Wallarrah 2 Coal Project

Review of the Mackie
Environmental Research Modelling Report,
field evidence and stakeholders comments

Dr F. R. P. Kalf
B.Sc, M.App.Sc, PhD
Kalf and Associates Pty. Ltd.
Hydrogeological and Numerical Modelling Specialists

27 October 2010

Figure 1 The “unprospective” Patonga Claystone formation underlying the majority of the mine site area and the major creeks (Taken from Mackie 2009 Figure 4)

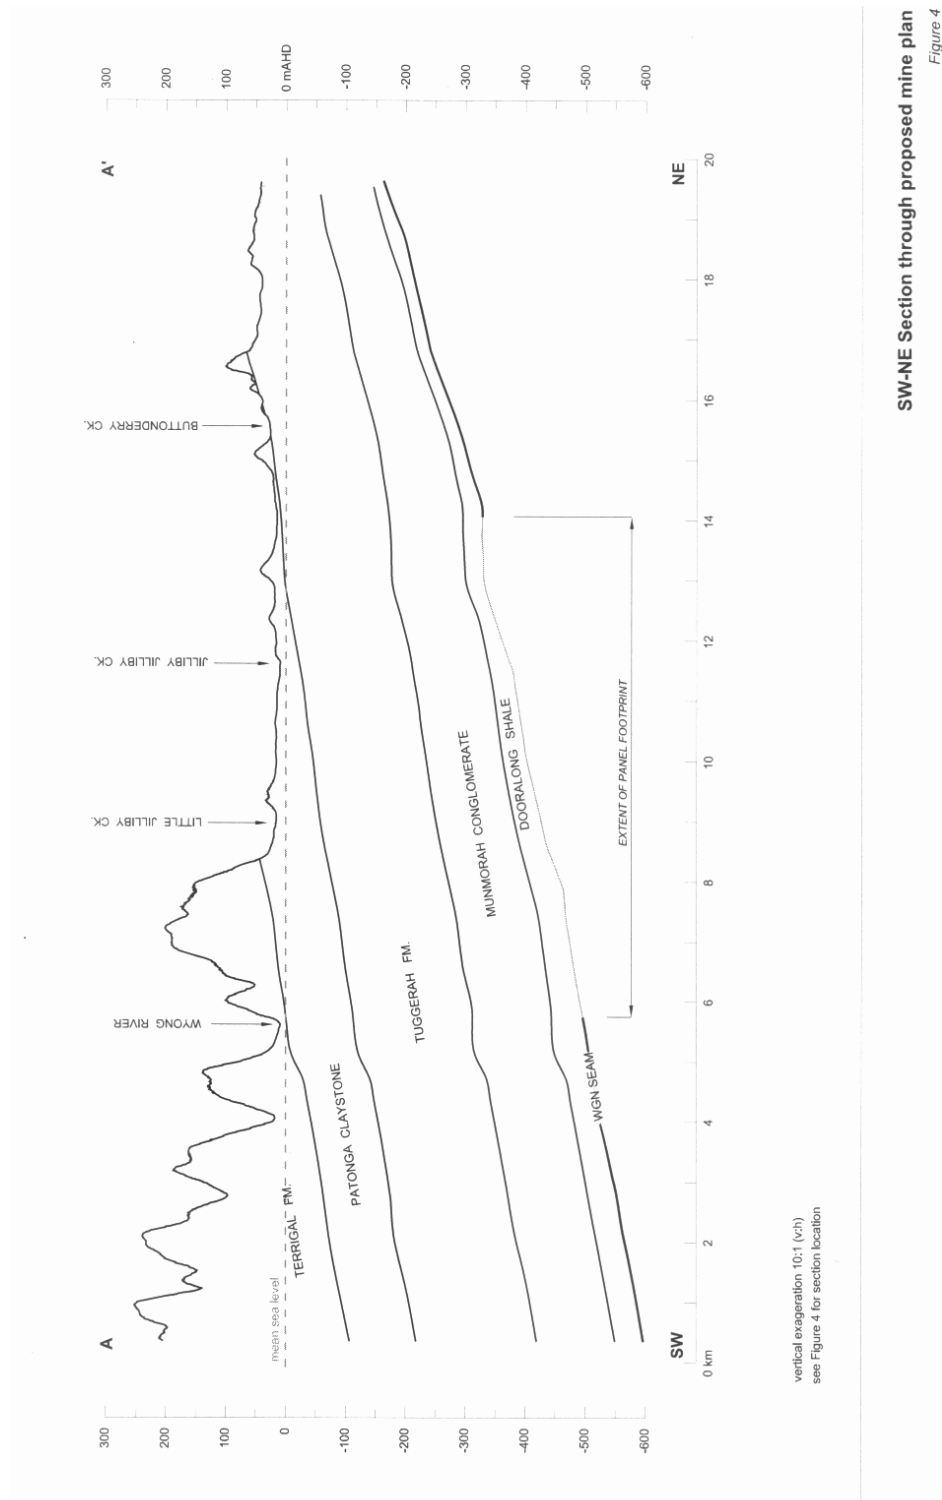
The PSM review indicates that Cook (2009) has reported an "***aggregate***" yield of 15 L/sec¹⁴ from bores constructed as part of the Gosford/Wyong emergency water supply. This yield is obtained from borefields in the uppermost Terrigal Formation in the strata sequence. The closest bores (Bangalow and Ourimbah creek borefields) are located some 11 kilometres south in a straight line from the southern boundary of the Wallarah 2 lease area.

More importantly, is that the Terrigal formation does not underlie the eastern part of the proposed mine site area and nor does it underlie the major creeks across the mining lease such as Jilliby Jilliby (Dooralong Valley) and lower part of Little Jilliby Creek (Figure 1 below on page 20). The uppermost formation underlying most of the coal lease and the creeks is the Patonga Claystone formation, the strata that Cook refers to as "***unprospective***". Later in the same paper Cook states: "***The underlying Patonga Claystone was assessed to have low potential for the discovery of useful flows of groundwater for the purpose. In addition, the quality of groundwater is generally poor with common high salinity levels.***" That is, the Patonga formation is of low permeability, and has very limited groundwater potential for the same reasons that the intervening strata down to the coal seam have virtually no groundwater potential as well as having a high groundwater salt content. The Terrigal formation comprising mainly sandstone only occurs along the elevated terrain in the western part of the mining lease with a groundwater potential that would be far less favourable.

Figure E4 verifies this in the EA Mackie report showing interpreted horizontal permeability profile for bore B250W300 that penetrates this formation at an elevated site. The profile shows no major difference between the Terrigal Formation horizontal permeability and the underlying Patonga formation. Any water bearing strata in the Terrigal formation would tend to be perched and hydraulically isolated from mine influence at a height of more than 500m above the seam (Figure 1). Therefore it would not be affected by panel extraction. These are the findings in a similar strata profile in the Southern Coalfield of NSW (Merrick 2009) where elevated groundwater circulation systems in the Hawkesbury Sandstone are perched water-bearing strata unaffected by mining.

Hence the reference to the Gosford/Wyong water supply site by the PSM review and the implication that the apparently localised highly fractured nature of that rock formation at these distant bore site locations would apply over the mine site is quite misleading.

Figure A1 SCT modeled 125m and 150m panel rock fracture development for the Hue Hue 3.0m and 4.5m coal extraction

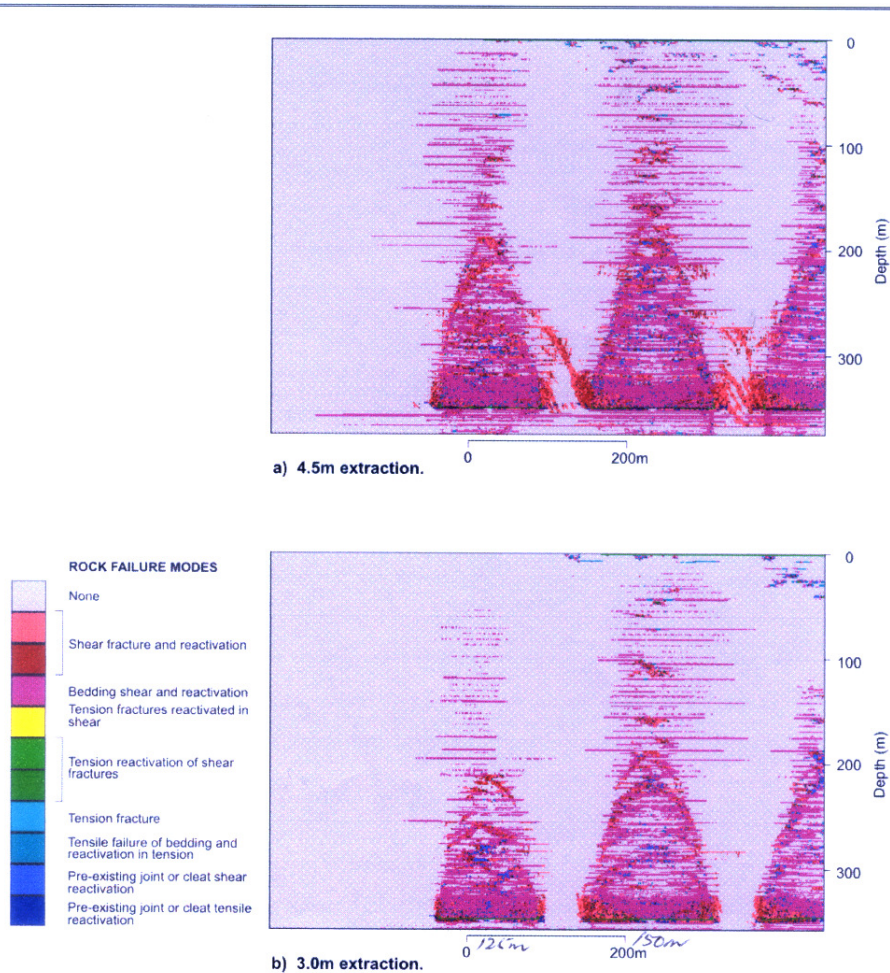
ultimate fracture development profile within the represented Narrabeen Group of sediments in the area of first stage mining (designated as the Hue Hue subsidence area) in response to panel removal. Simulations included two panel widths, 125m and 150m for a constant overburden thickness of 350m. For each simulated case a coal seam of 3m and 4.5m within the 6m thick seam were used.

The results show the presence of a zone of rock collapse immediately above the seam; a severely fractured and sheared 'parabolic' zone above that and then mostly irregular horizontal fracturing and bedding separation (colored red) within the upper part of the sequence with some isolated shearing.

The limited depth of slightly increased vertical fracturing and vertical permeability at the ground surface due to panel extraction in the Figures A1 and A2 is also worth noting. However, the shallow vertical connectivity does not extend very far below the surface because the slightly higher shallow vertical permeability decreases rapidly below about 10m -15m (Figure A2).

of the isolated nature of this fracturing, its variable distribution above individual panels and the evident lack of strong connection of these fracture zones between panels and outside the mining footprint (Figure A1).

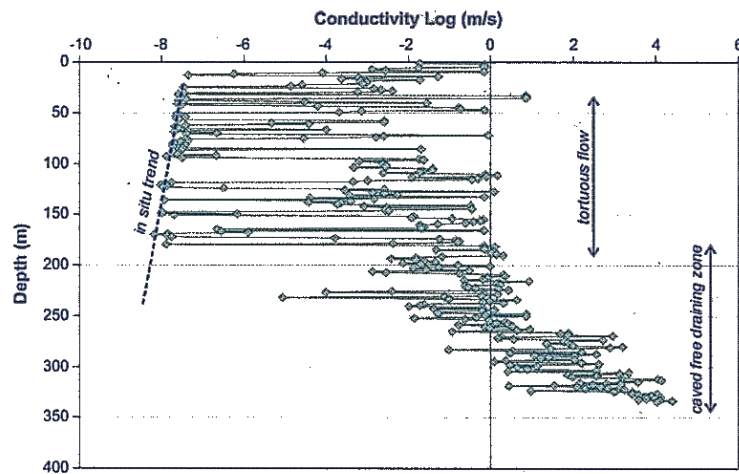
Finally, the fracture simulations conducted by SCT/MSEC (2010) (See Appendix A, Figure A2) show that shallow vertical fractures with slightly higher vertical permeability only occur sporadically in the Hue Hue area W2CP profile within 10m to 15m from the surface.

Figure A2 (see below) shows the vertical hydraulic conductivity (permeability) of the above profile from the same report. This shows numerous layers in the upper parts of the profile that retain or are close to their pre-mine insitu vertical permeability (values on the left side of the graph).
